# Access Compliance Report

## Public Rights-of-Way

### (Curb Ramps)

Intersection ID: 18350	Main Street: PROVIDENCE_RD	Cross Street: SHARON_LN	Location: NE
ADA ID: 5AF9236ECDBA	Ramp Type: Para	Initial Pass/Fail: Fail	Overall Compliance: No
Severity Score: 26.25			
Codes/Mitigation Info/Possible Solution		Field Measurements/Component Compliance

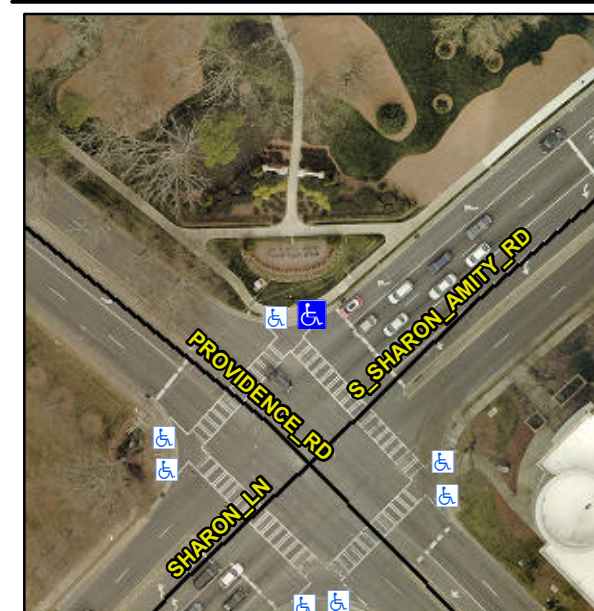
Possible Solutions:

**Remove & Replace Entire Ramp.**

PROW/ADA:

**R304.5.3, R304.3.2**

Compliance	Description	Data	Compliance	Description	Data
N/A	Ramp Length LT (in)	59.0	N/A	Ramp Length RT (in)	64.0
Yes	Ramp Width LT (in)	83.0	Yes	Ramp Width RT (in)	83.0
Yes	Ramp Slope LT (%)	5.7	No	Ramp Slope RT (%)	12.2
No	Ramp XSlope LT (%)	3.6	Yes	Ramp XSlope RT (%)	1.0
N/A	Landing Length (in)	N/A	N/A	DWS Provided?	N/A
N/A	Landing Width (in)	N/A	N/A	DWS Contrast?	N/A
N/A	Landing Slope (%)	N/A	N/A	DWS Length (in)	N/A
N/A	Landing X Slope (%)	N/A	N/A	DWS Full Width?	N/A
N/A	Landing Curb? (Y/N)	N/A	N/A	DWS Offset (in)	N/A
N/A	Shared Landing?	N/A			
N/A	Gutter Ponding?	N/A	N/A	Gutter Slope (%)	N/A
N/A	Gutter Lip Ht (in)	N/A	N/A	Gutter X Slope (%)	N/A
N/A	Painted X Walk1?	Yes	N/A	Painted X Walk2?	N/A
	X Walk 1 Direction	To SE		X Walk 2 Direction	N/A
N/A	X Walk 1 Width (in)	108.0	N/A	X Walk 2 Width (in)	N/A
	X Walk 1 Slope (%)	0.8		X Walk 2 Slope (%)	N/A
	X Walk 1 X Slope (%)	0.7		X Walk 2 X Slope (%)	N/A
N/A	Ramp inside XWalk1?	Yes	N/A	Ramp inside XWalk2?	N/A

Road Slope (%)	N/A	N/A	Clear Space?	N/A
	Road X Slope (%)	N/A	N/A	Clear Space to XWalk (in)	N/A
N/A	Any Obstructions?	N/A	N/A	Storm Grate/Utility Hazard?	N/A
	Obstruction Type			Storm Grate/Utility Type	
		N/A			N/A
			Yes	Surface Condition? (G/P)	Good
			N/A	Curb Slope (%)	11.4
